**CITY OF GLENDALE, CA
REPORT TO THE DESIGN REVIEW BOARD**

DESIGN REVIEW STAFF REPORT – MULTI-FAMILY / MIXED USE

July 9, 2020 <i>Decision Date</i>	227 West Dryden Street <i>Address</i>
Administrative Design Review (ADR) <i>Review Type</i>	5636-011-044 <i>APN</i>
PDR2002014 <i>Case Number</i>	Hamlet Zhorabians <i>Applicant</i>
Minjee Hahm <i>Case Planner</i>	Levik Hagobian for Icon LLC <i>Owner</i>

The applicant is proposing to construct a new, two-story, six-unit apartment building over semi-subterranean parking garage on an approximately 8,210 SF, vacant lot located in the R-1250 (High Density Residential) Zone.

SHEET TITLE:
 PROPOSED SITE PLAN AND
 FIRST FLOOR PLAN

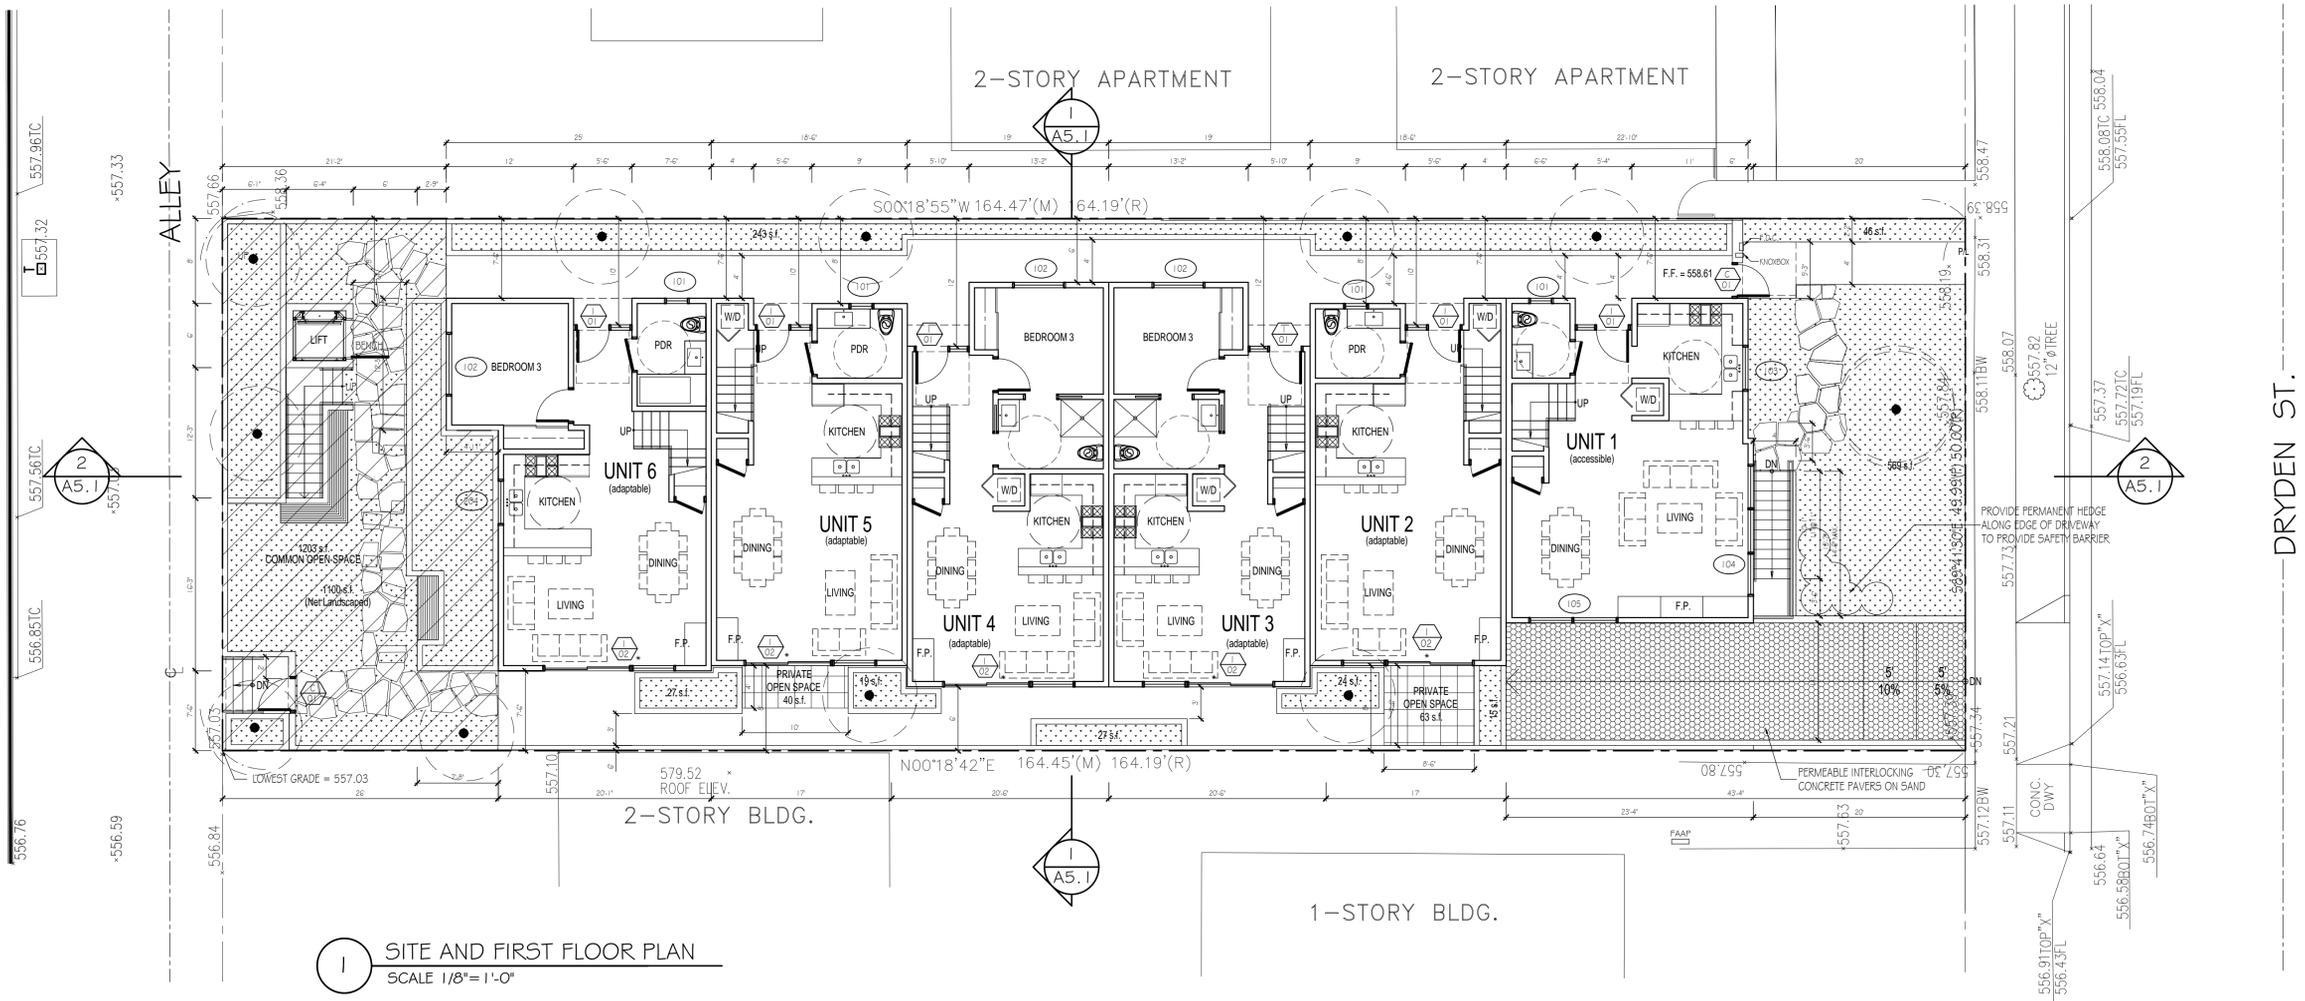
The new semi-subterranean parking garage will be accessed from West Dryden Street. Pedestrian access to the semi-subterranean parking garage is from the front with stairs appropriately incorporated into the overall design of the building. The applicant's proposal includes a 11-foot wide driveway constructed with decorative pavers. A

condition of approval is added requiring that the applicant provide details for the proposed pavers prior to plan check submittal.

3. Revise drawings to relocate the stairs and lift centrally located in the proposed common open space to be closer to the rear property line, in order to make the common open space area more functional for staff review prior to plan check submittal.

1. Provide details for the proposed driveway pavers prior to plan check submittal.
2. Obtain a letter from the gas company permitting the proposed location of the gas meter in the semi-subterranean parking garage. In the event that the proposed

SHEET TITLE:
 PROPOSED SEMI-SUBTERRANEAN PARKING GARAGE

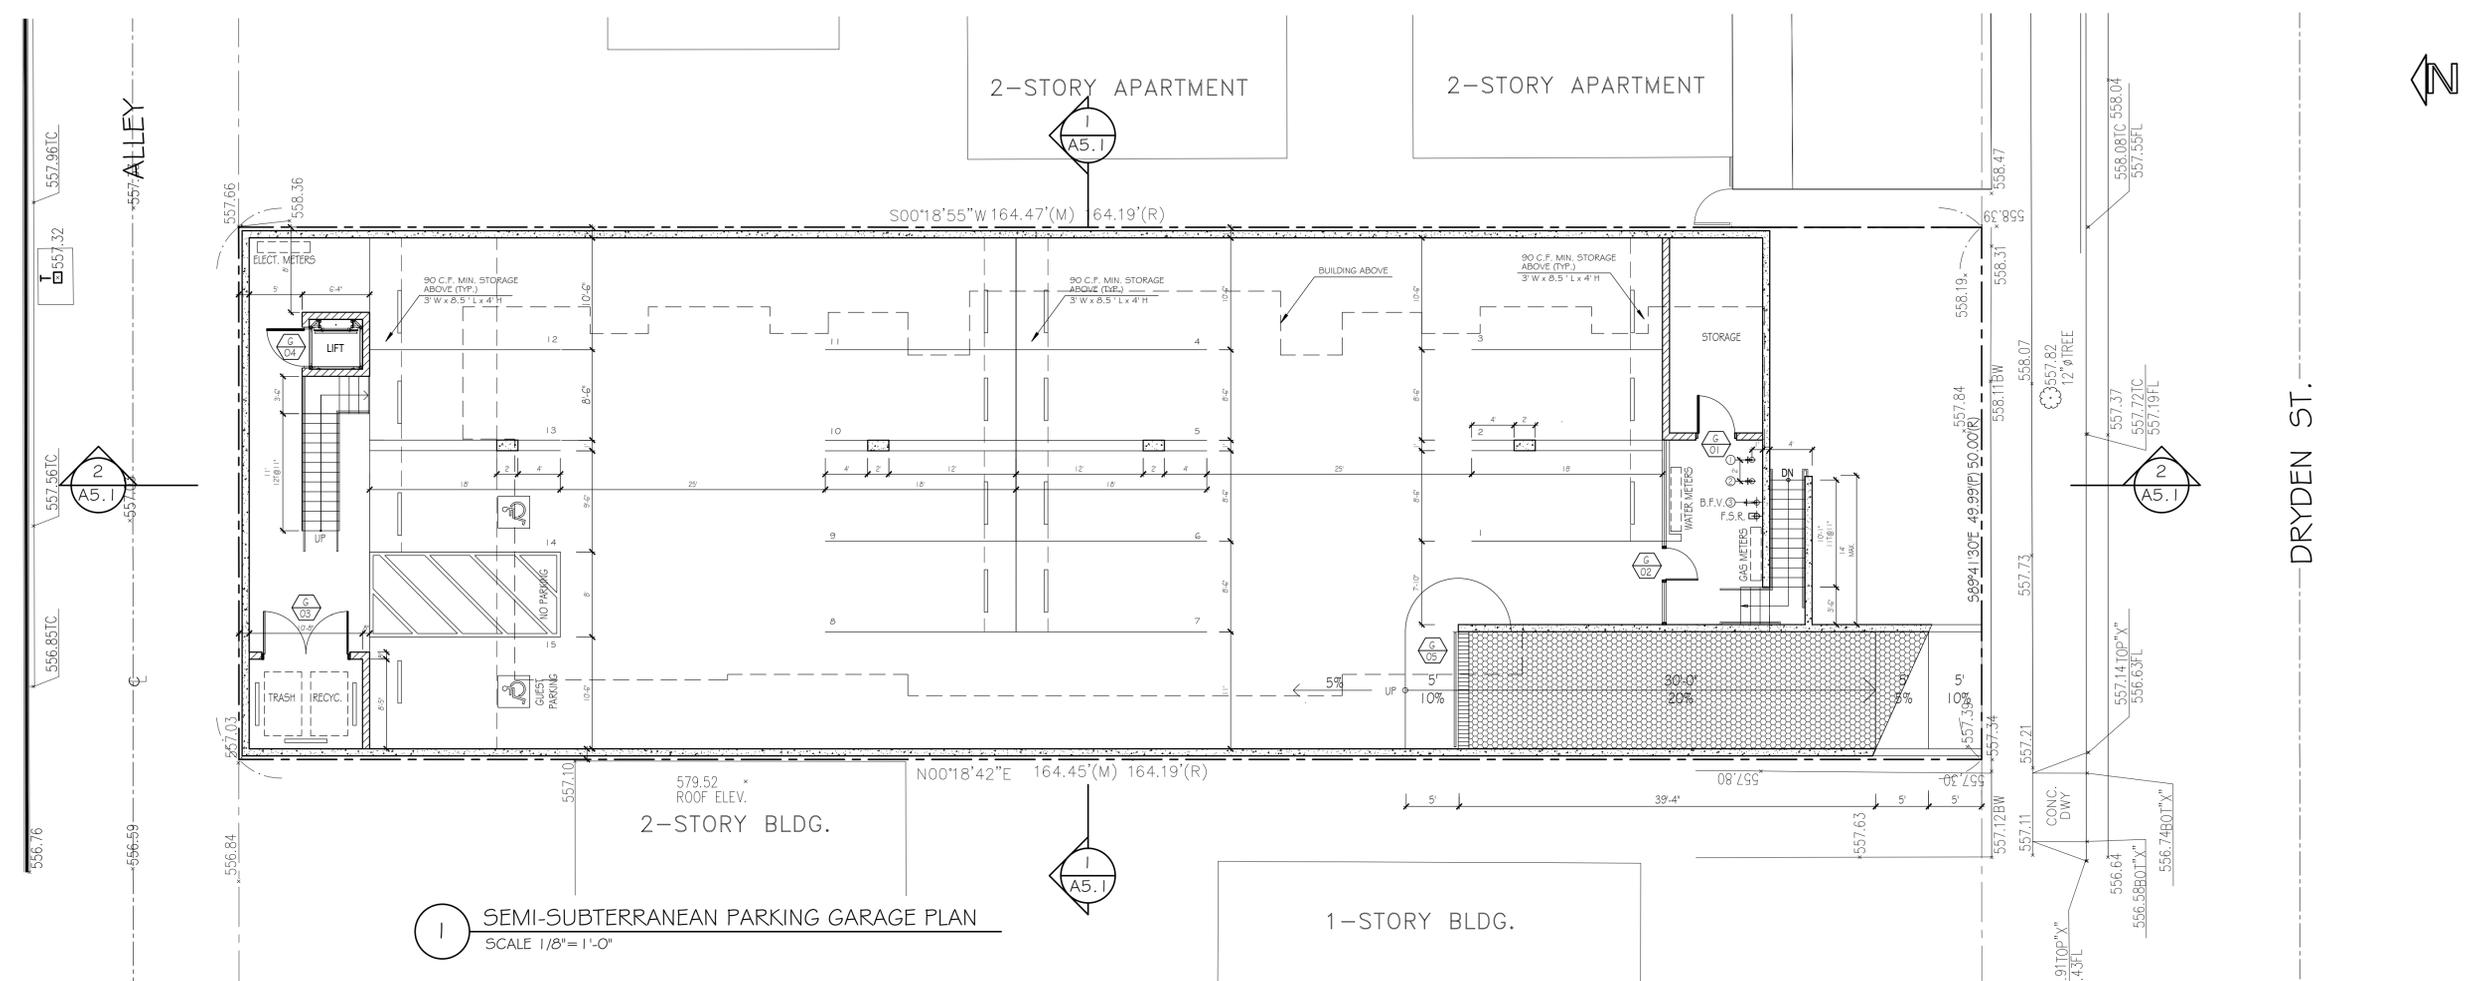
The trash bins and recycling containers are located in the semi-subterranean garage and adequately screened from public view. Metal downspouts and gutters are appropriately integrated into the roof. All utility meters are proposed to be in the semi-subterranean garage. A condition of approval is added requiring that the applicant obtain a letter from the gas company permitting the proposed location of the gas meter in the semi-subterranean parking garage. In the event that the proposed location is not permitted, applicant will have to revise drawings to show a new location for the gas meter that complies with all applicable Zoning Code regulations.

location is not permitted, applicant will have to revise drawings to show a new location for the gas meter that complies with all applicable Zoning Code regulations and Design Guidelines.
